Acorn House 314-320 Gray's Inn Road, London

Acoustic Design Review
Report 26359.ADR.01 RevA

Report 26359.ADR.01			
Revision History			
First Issue Date: 08/12/2023			
A	13/01/2025 Assessment of external building services.	D	
B		E	
C		F	
Written by:		Checked by:	
Jacob Tyler-White MIOA Principal Acoustic Consultant		Daniel Stuart MIOA Principal Acoustic Consultant	
Disclaimer KP Acoustics Ltd. has used reasonable skill and care to complete this technical document, within the terms of its brief and contract with the resources devoted to it by agreement with the client. We disclaim any responsibility to the client and others in respect of any matters outside the stated scope. This report is confidential to the client and we accept no responsibility to third parties to whom this report, or any part thereof, is made known. KP Acoustics Ltd. accepts no responsibility for data provided by other bodies and no legal liability arising from the use by other persons of data or opinions contained in this report. KP Acoustics Ltd. 2023

Figure 2.1 Ideal flanking strip placement

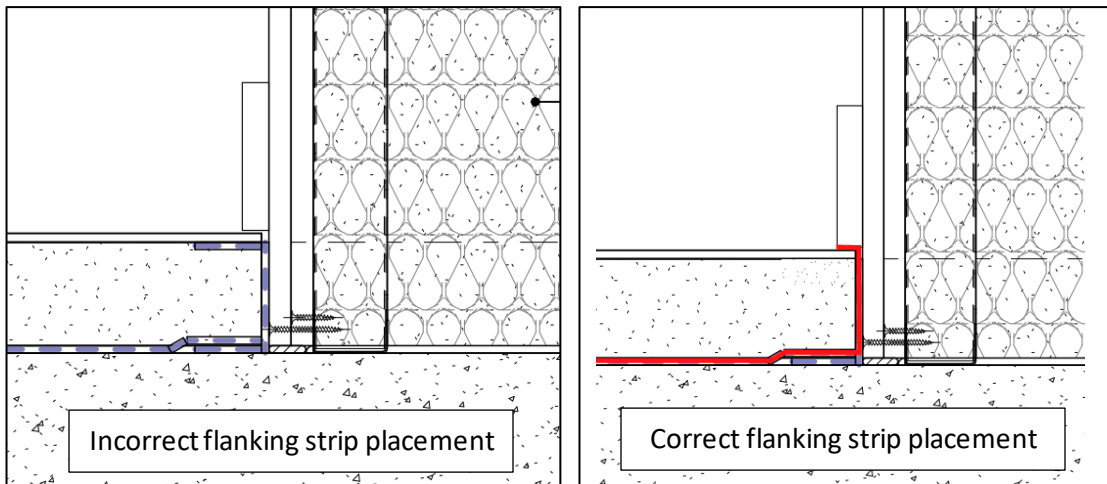
It has been noted that flanking strips have been proposed to lap up at the separating wall and under the floor finish. This is incorrect, however, and we would recommend that the resilient layer is lapped up under the skirting board and above the floor finish.

Figure 2.2 KPA proposed junction detail

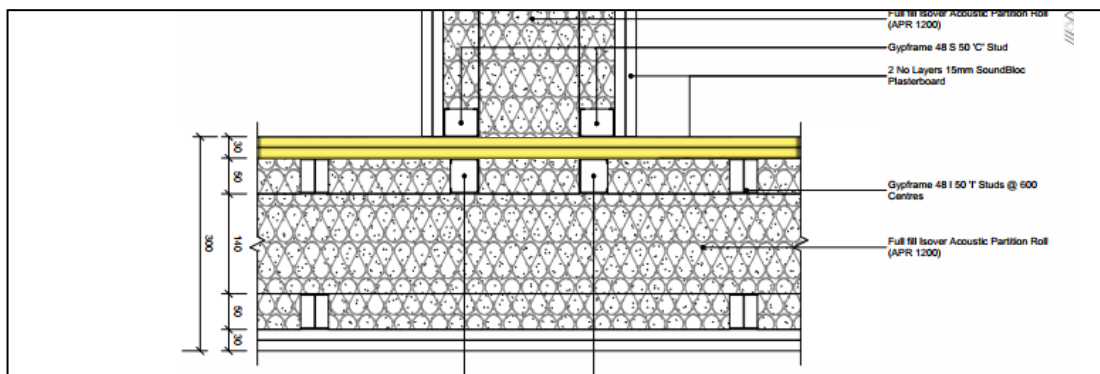
Party Wall to Party Wall ‘T’ Junction Plan (ref. dl.04)

In order to prevent flanking through the wall cavities, we would recommend that the SoundBloc is continuous as presented in the following detail:

FIGURE 26359.DWG1

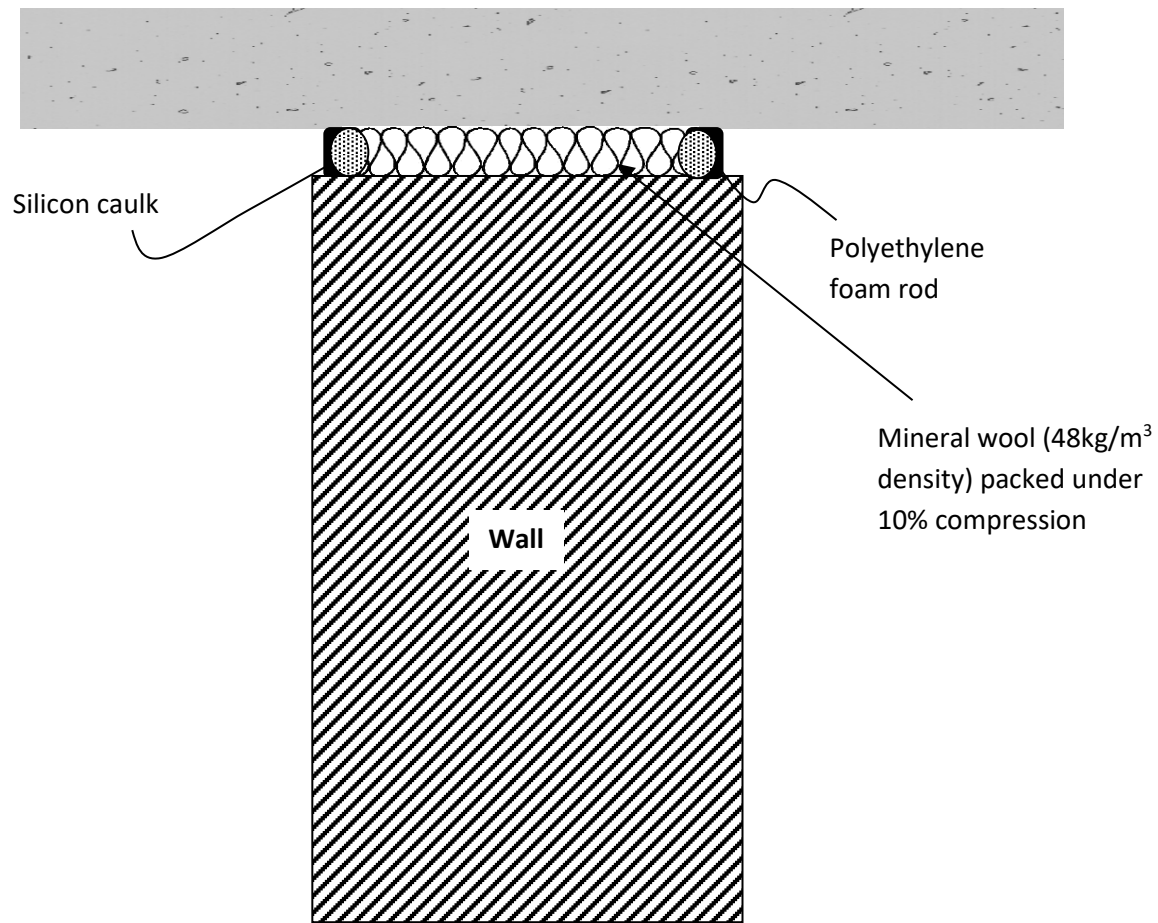
Ideally, a gap between the head of the wall and the underside of the soffit should not be greater than 10mm. A polyethylene backing rod could be inserted in the gap with tightly

packed mineral wool while silicone caulk is used to seal the joint. When constructing cavity walls, care should be taken not to drop debris into the cavity, which may bridge the leaves of construction. The aforementioned detail is illustrated in DWG. 1.

FIGURE 26359.DWG2

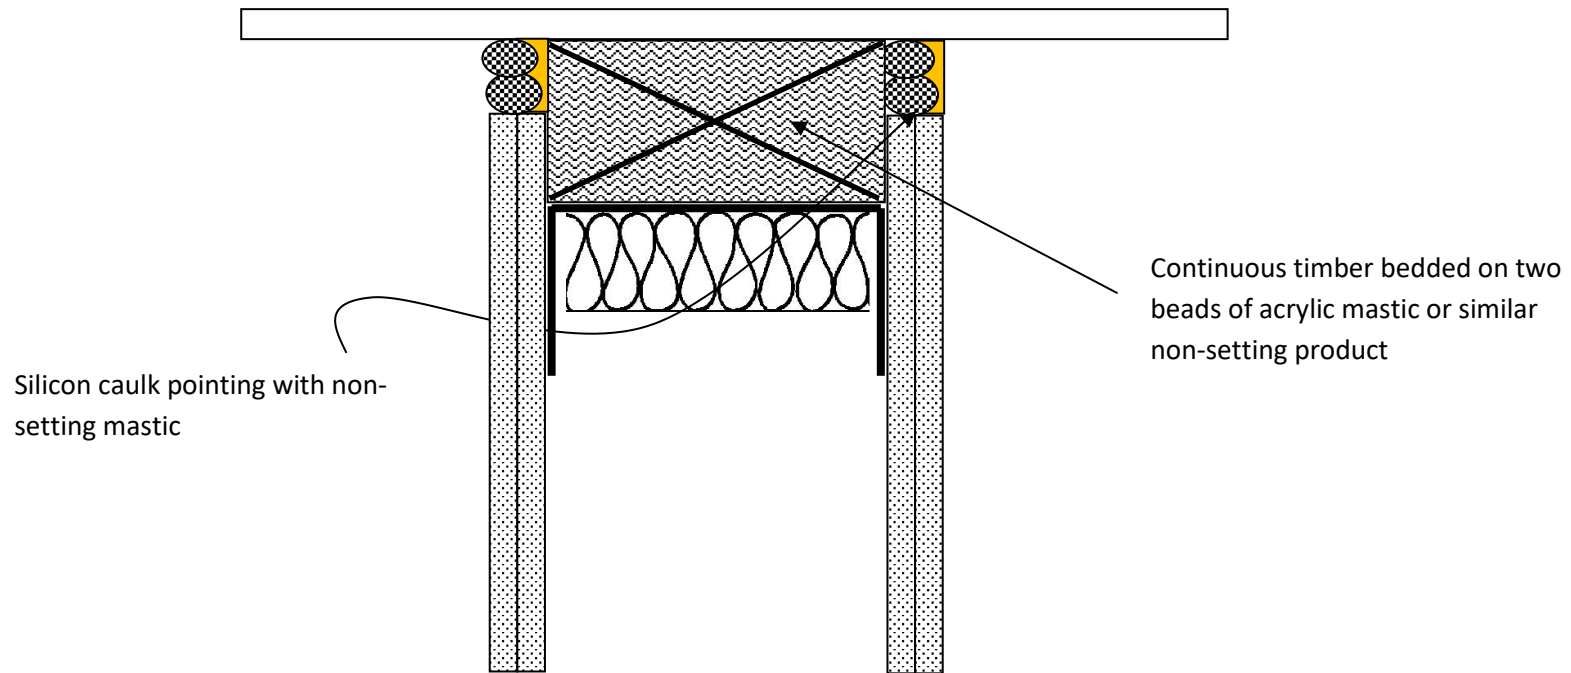
Timber/Metal Stud walls should be built using the correct deflection head to minimise flanking transmission of noise. The correct detail is illustrated in DWG. 2.
